# Submissions Report Stage 2 – Stations, Rail Infrastructure and Systems

Incorporating Preferred Infrastructure Report

MARCH 2013

**northwest**raillink

Figure 2.1 Bella Vista Station access from Glenwood – existing and proposed

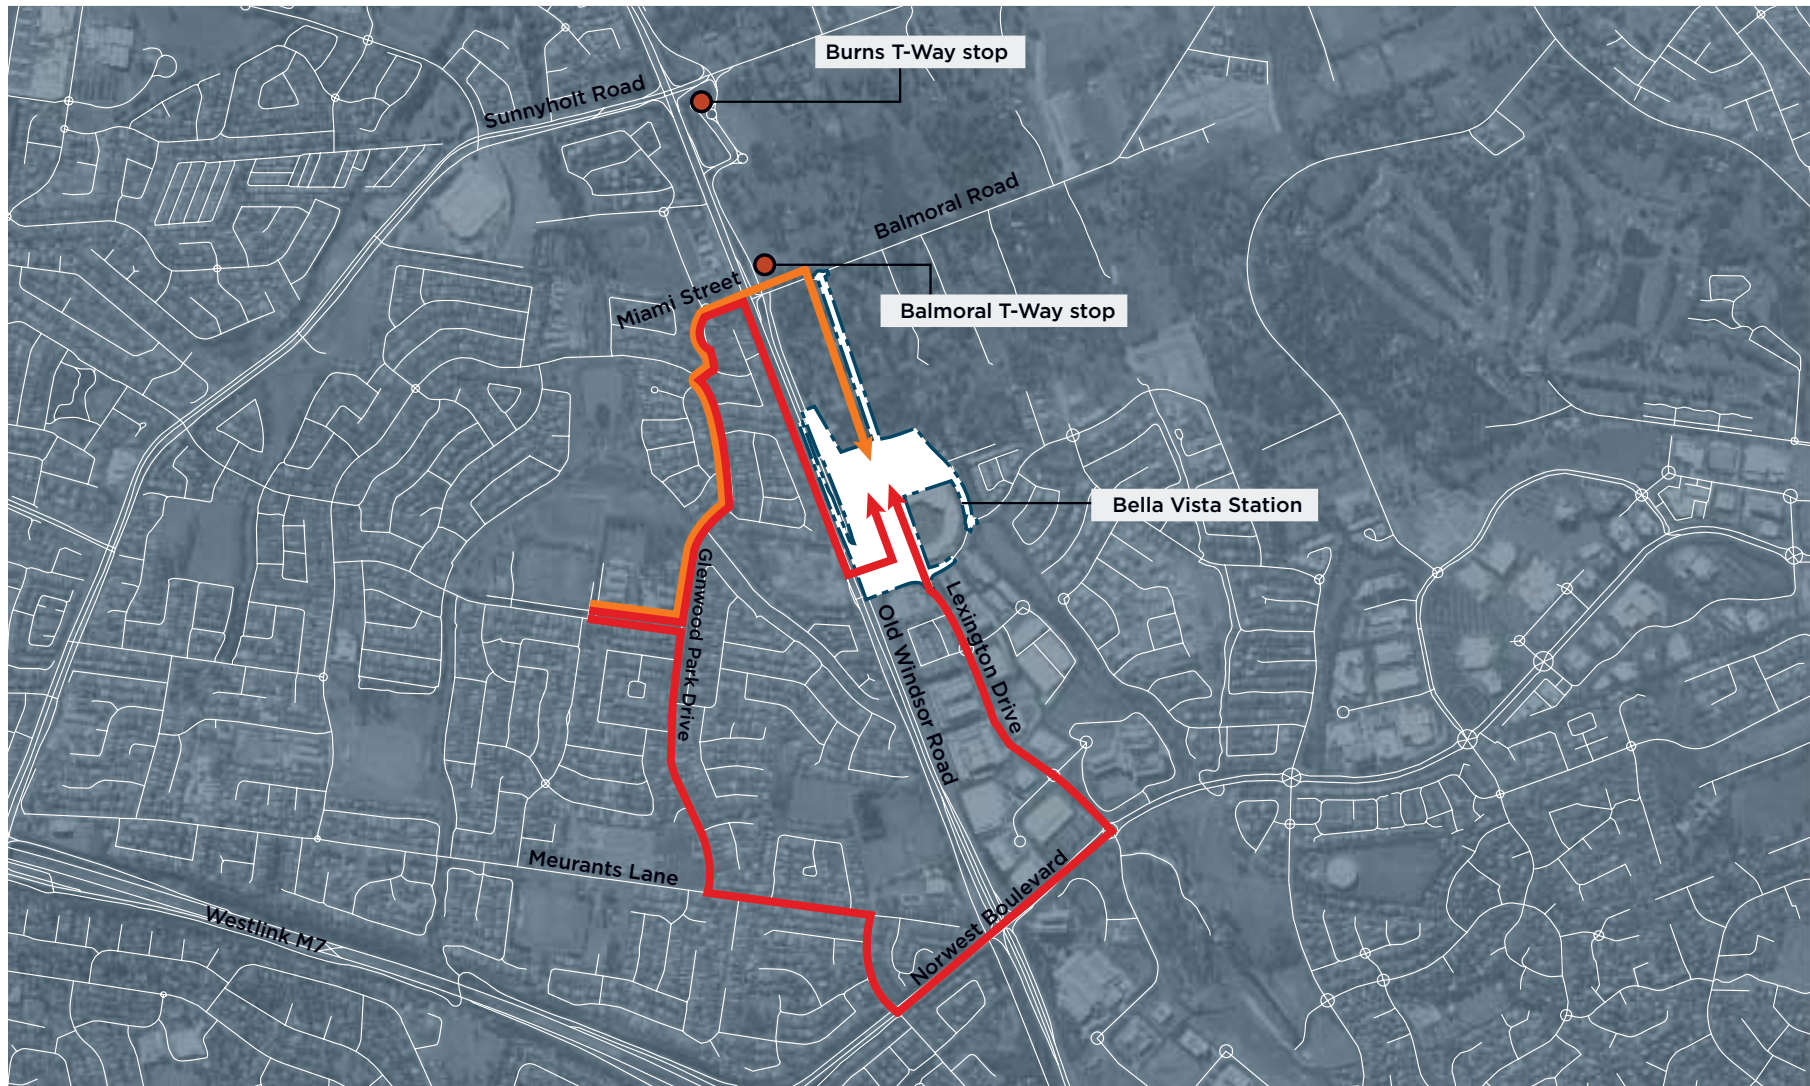
In response to ongoing design refinements and feedback received from Deliberative Research Forums, and in consultation with Roads and Maritime Services (RMS), improvements to the wider road network have been identified to better manage traffic and improve Bella Vista Station access over time.

The existing Balmoral T-Way stop would be relocated approximately 30 metres to the north. The location of the proposed Balmoral Road overbridge across the rail cutting would be moved slightly further north and its width would be increased to provide for two traffic lanes in each direction and pedestrian footpaths on each side of Balmoral Road.

Figure 2.2 Bella Vista Station access from Glenwood with the proposed intersection arrangement

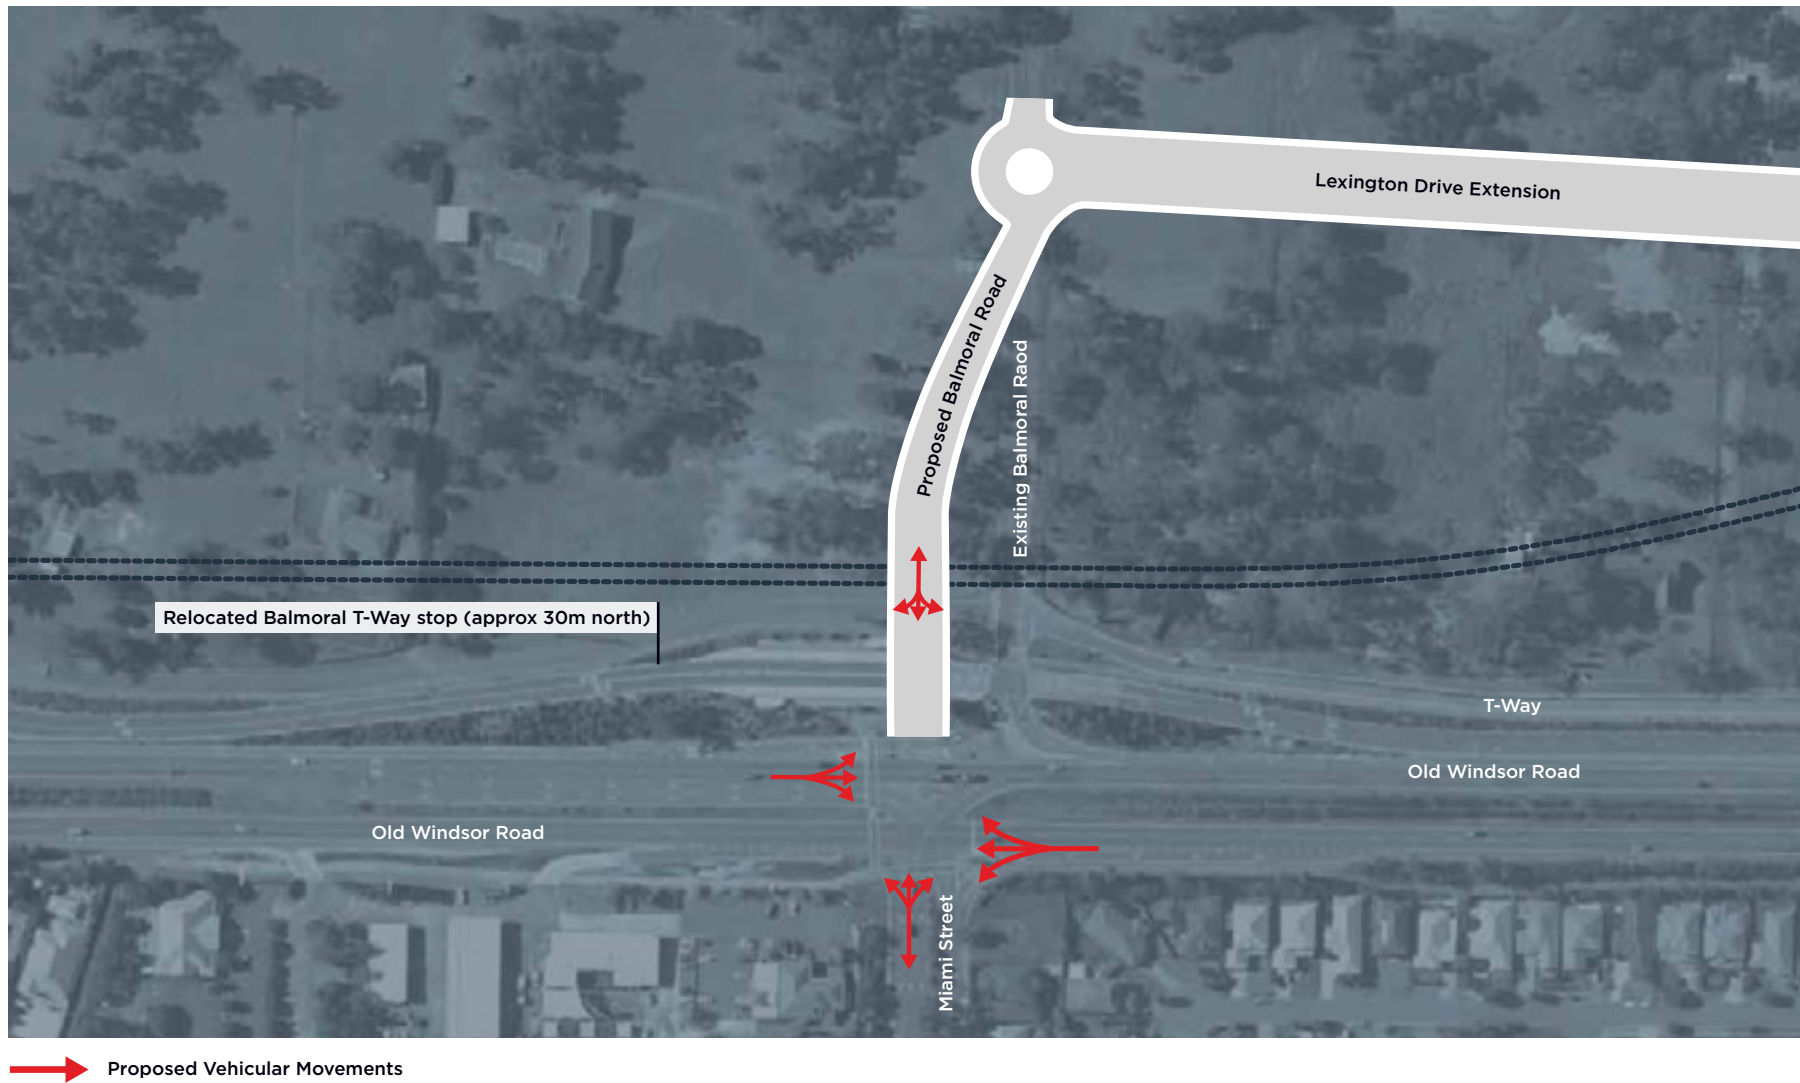
The proposed arrangement at the Old Windsor Road / Balmoral Road / Miami Street intersection consists of realigning Balmoral Road approximately 30 metres to the north to provide a direct connection to Miami Street. The proposed intersection arrangement is illustrated in **Figure 2.2**.

The proposed intersection arrangement would bring traffic and accessibility benefits including:

- ❖ The extension of the Bella Vista Station catchment on the western (Blacktown Local Government Area) side of Old Windsor Road by the provision of a new and more direct access route between Glenwood residential area and the proposed Bella Vista Station and precinct.
- ❖ The improvement of east-west connectivity between the Glenwood residential area and the Balmoral Road Release Area.
- ❖ Opportunities for more direct bus services from Glenwood to Bella Vista Station and the Norwest employment centre.
- ❖ An at-grade pedestrian access across Old Windsor Road and the T-Way which would complement the proposed pedestrian bridge over Old Windsor Road.
